Architectural Review Board

Staff Report

Subject: **500 University Avenue [13PLN-00391]**: Request by Thoits Brothers Inc. for Major Architectural Review to allow the construction of a new 26,806 sq. ft. three-story office and retail building in the CD-C (GF) (P) zone district replacing the one-story 15,899 sq. ft. commercial building. The project includes a Design Enhancement Exception (DEE) request to allow roof-top elements to exceed the 50 foot height limit by a maximum of 11 feet. Environmental Assessment: Exempt from the provisions of the California Environmental Quality Act (CEQA) per CEQA Guidelines Section 15332.

SITE PLAN:

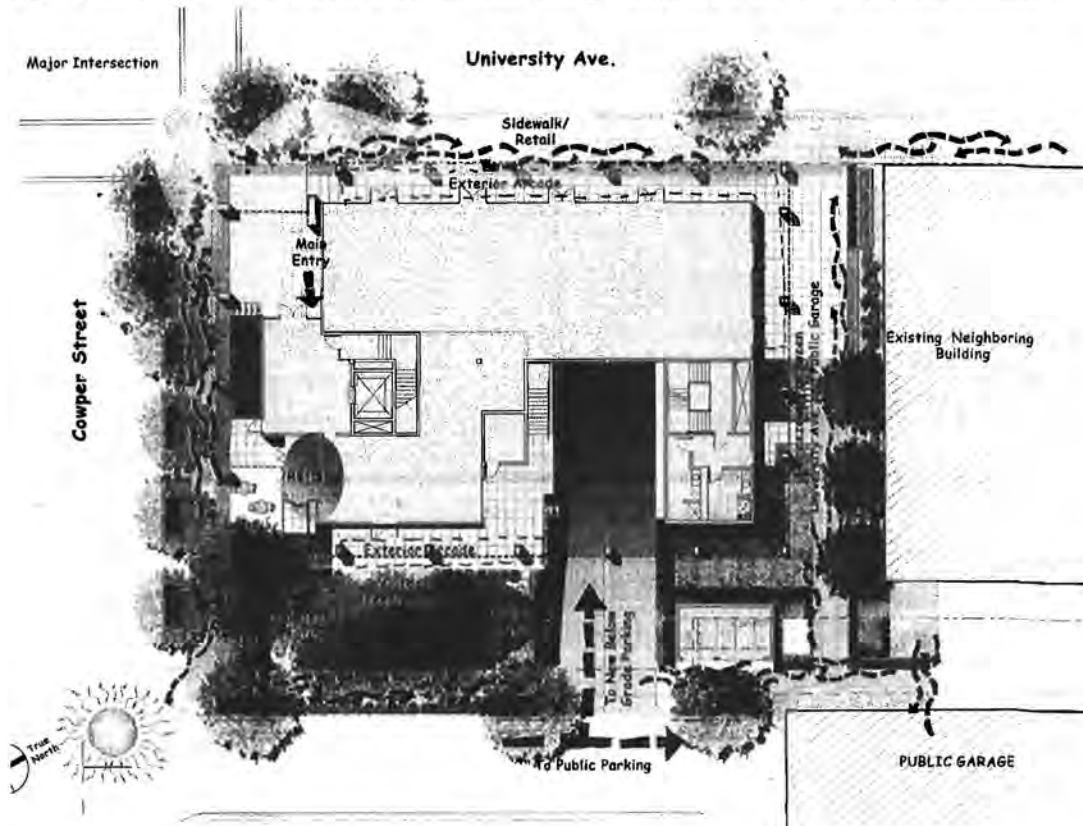
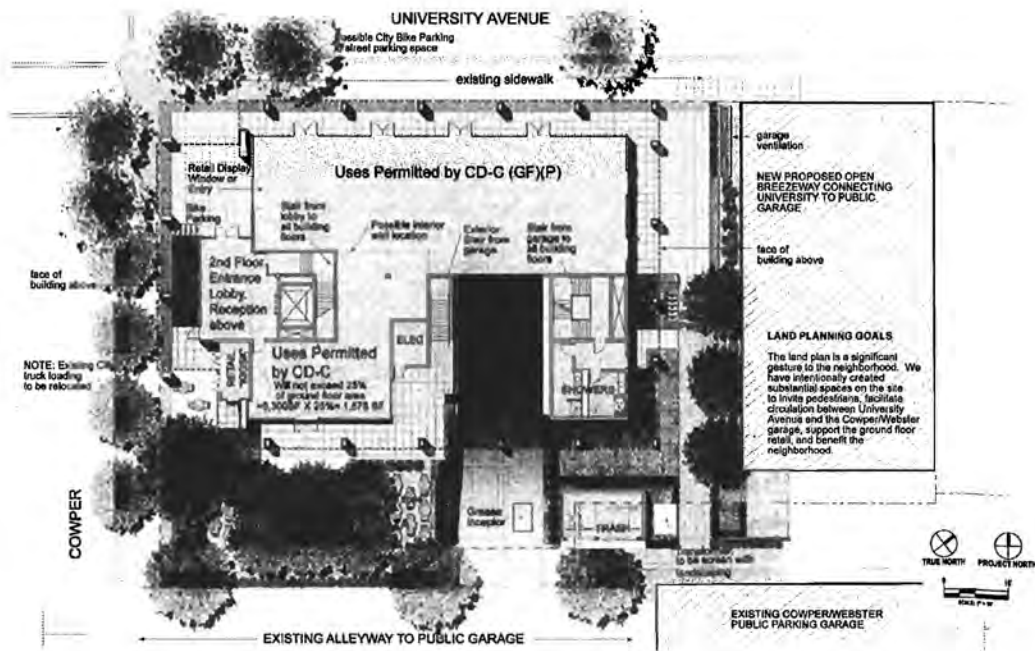
The following two images show the master plan concept, and then the current design. Please also note that the project now proposes two levels of below grade parking - 42 spaces in excess of code requirements.

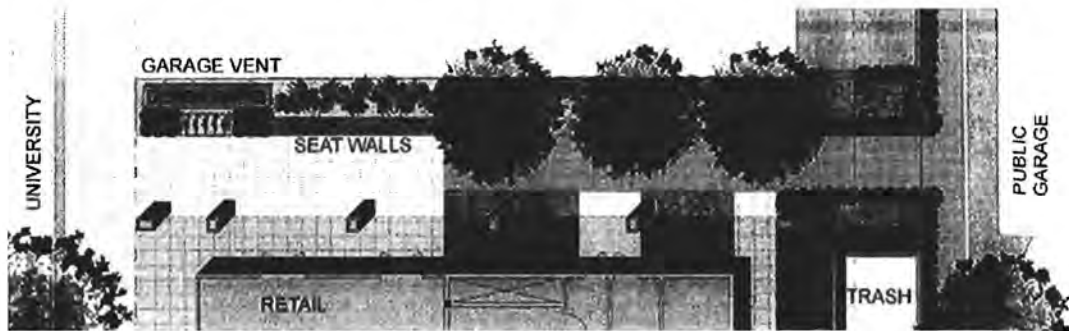
- b) Retail Arcade: To ground the building, and make the retail arcade warm and inviting we propose transitioning the standard public sidewalk concrete with a dark grey band to land the columns, and then a medium grey paver in the arcade. This pallet of pavers is used throughout the project. The aluminum sunshade / light shelf is also the signage support. Please refer to sign program pages for those images.

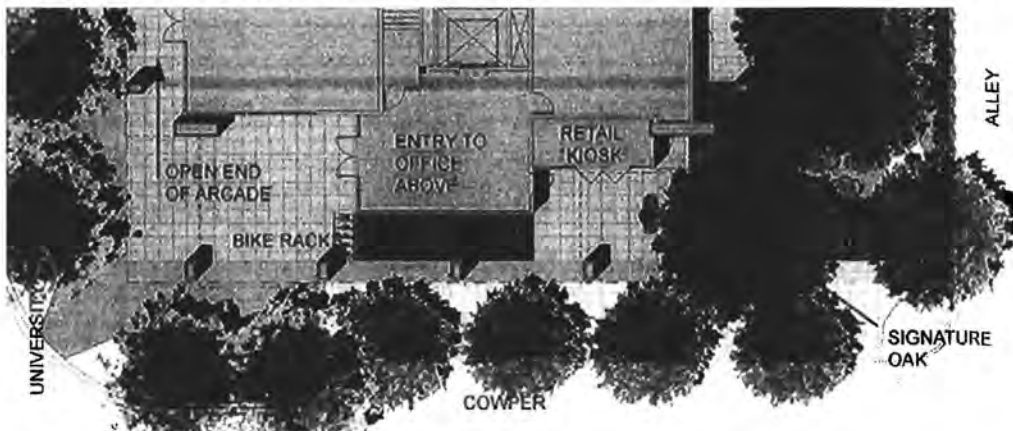
- c) Breezeway: The breezeway has been made wider (20' from property line at the upper levels as before, and now 28' at the ground level). It is divided into a retail zone at University, and a more landscaped zone as you make your way to the garage. This helps moderate the length of the connector into nicely scaled parts. Bike parking has been well distributed with racks on the surface, and "long term" located in the garage. The trash enclosure will be rebuilt, and remains generally in it's current location at the alley for easy trash pick up. It has been sized for this project and its neighbors.

The breezeway between University and the Cowper garage is generous, and is activated by retail shopfronts.

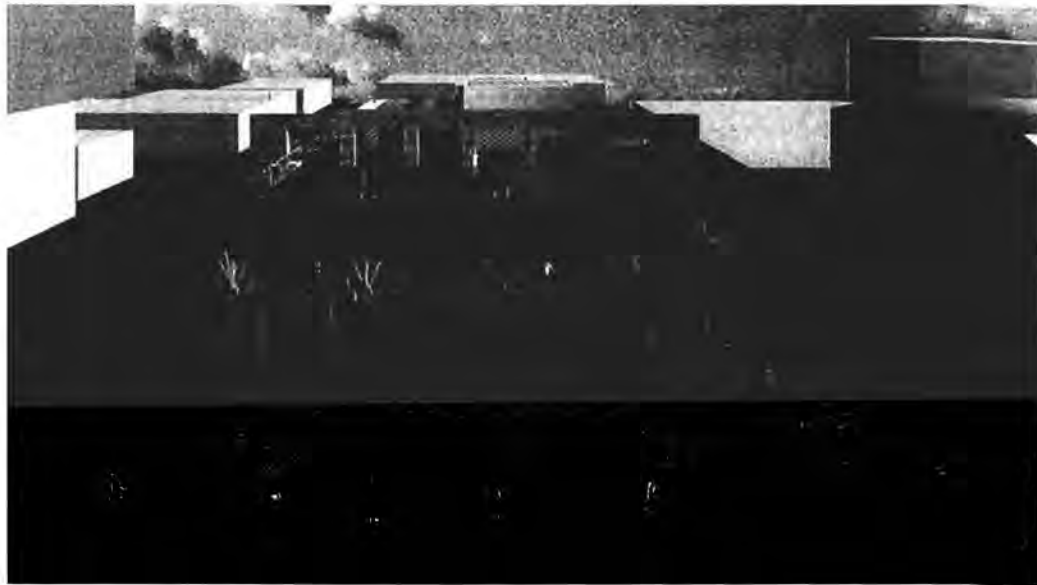
- During our Study Session it was noted that the floor to floor heights seemed tall. We have now reduced them to 16', 14' and 14'. Besides improving proportions, this dropped the overall building height by 3'.
- There was also concern that the proposed rustic stone on the armature seemed odd in this application. We now propose smooth stone for both the "armature," and what had formerly been the GFRC wall panels. Sample of proposed stone shown below.

SIGNAGE

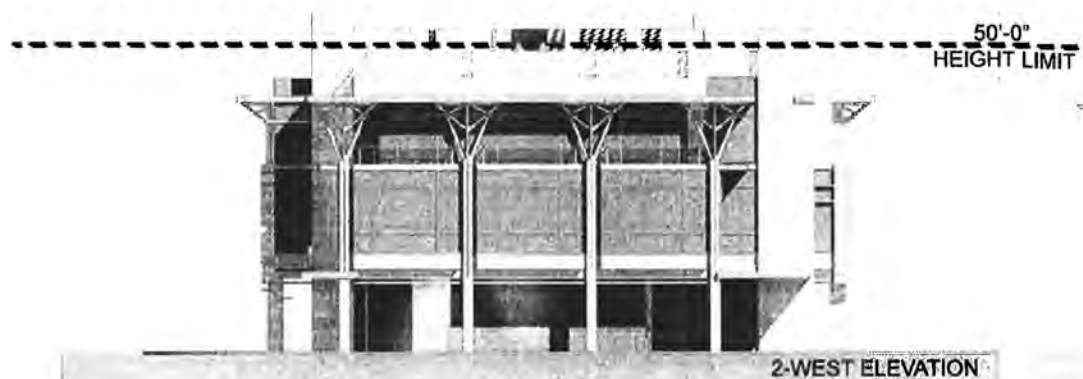
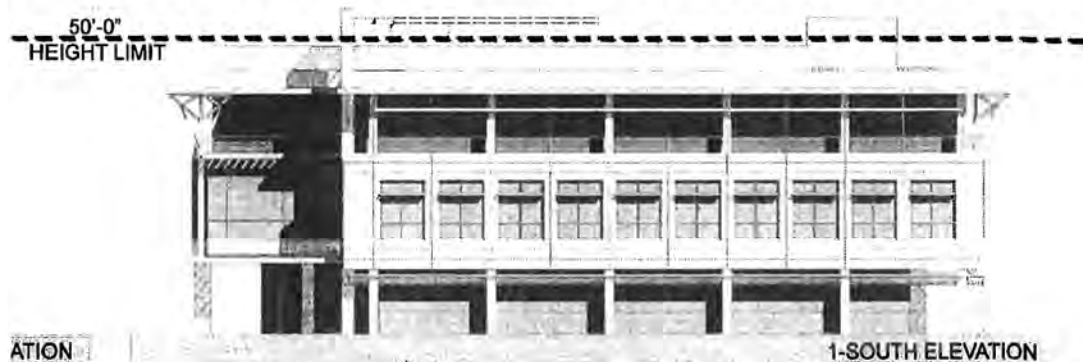
- a) The sunshade / light shelf along University and been redesigned to integrate the building signage. We have also indicated proposed locations for office tenant signs in various location. Please refer to the full package for signage program detail.
